Your Ref
BN/69/16/PL
Our Ref
PLAN-017101
Date
28/02/2017

Proposal: 5 no. dwellings comprising 2 no. 4- bed houses, 2 no. 3- bed houses and 1 no. 3- bed bungalow, with access and ancillary works
Site: Land East of Toll Cottage Lake Lane, Barnham, PO22 0AD.
BN/69/16/PL

Due to surface water inundation issues in the Lidsey Catchment "The applicant is advised to adopt, where appropriate, the measures in the table "Practical measures to reduce the potential impacts of development".

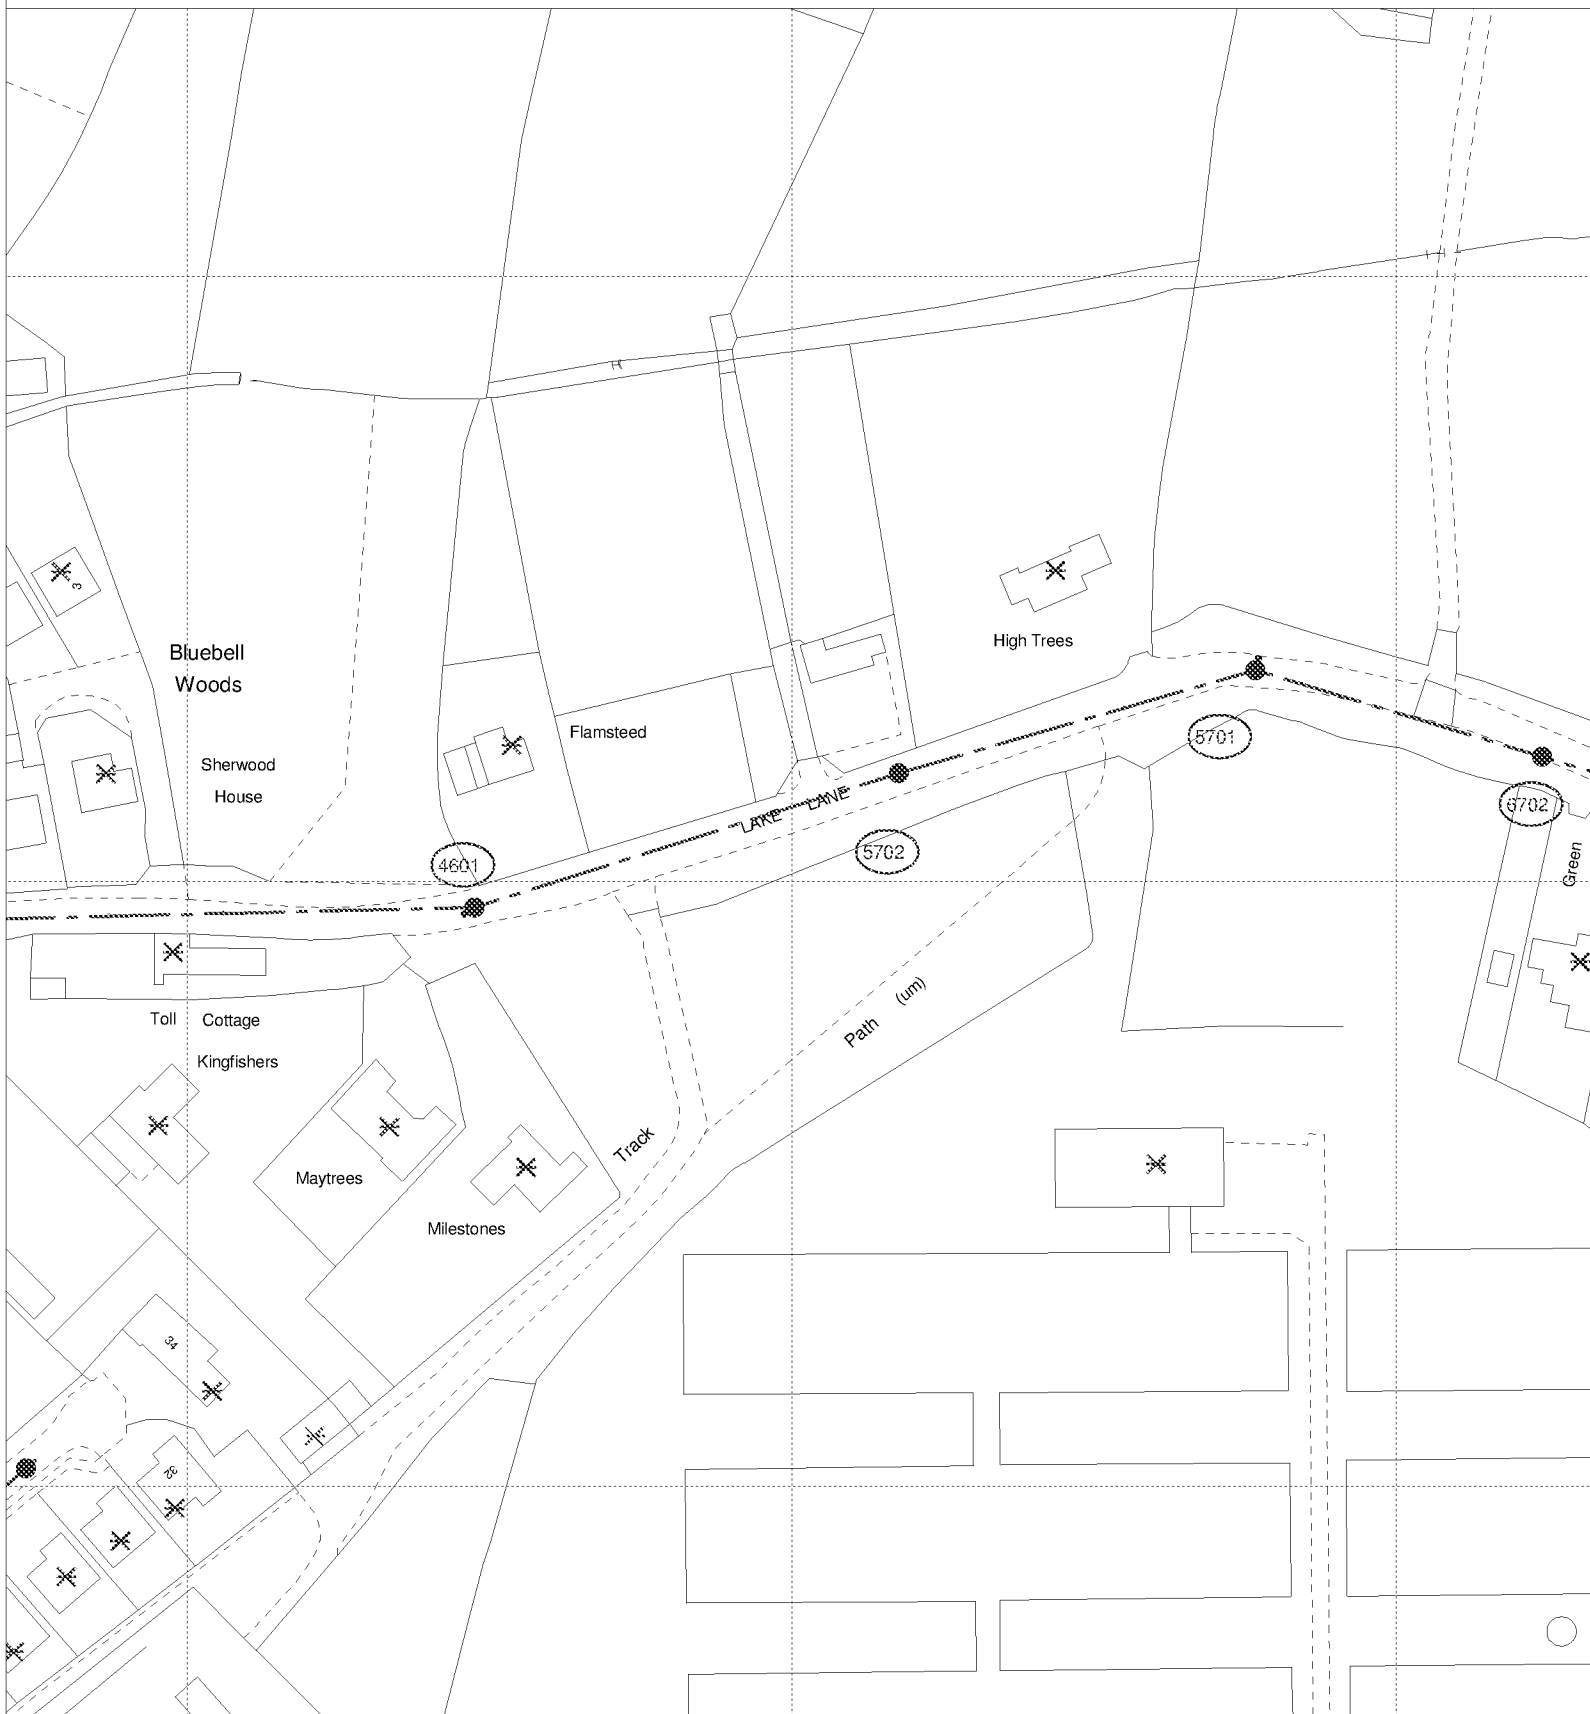
Developer should look to protect the public sewerage system from inundation and infiltration, which contribute to flooding in unfavourable conditions.
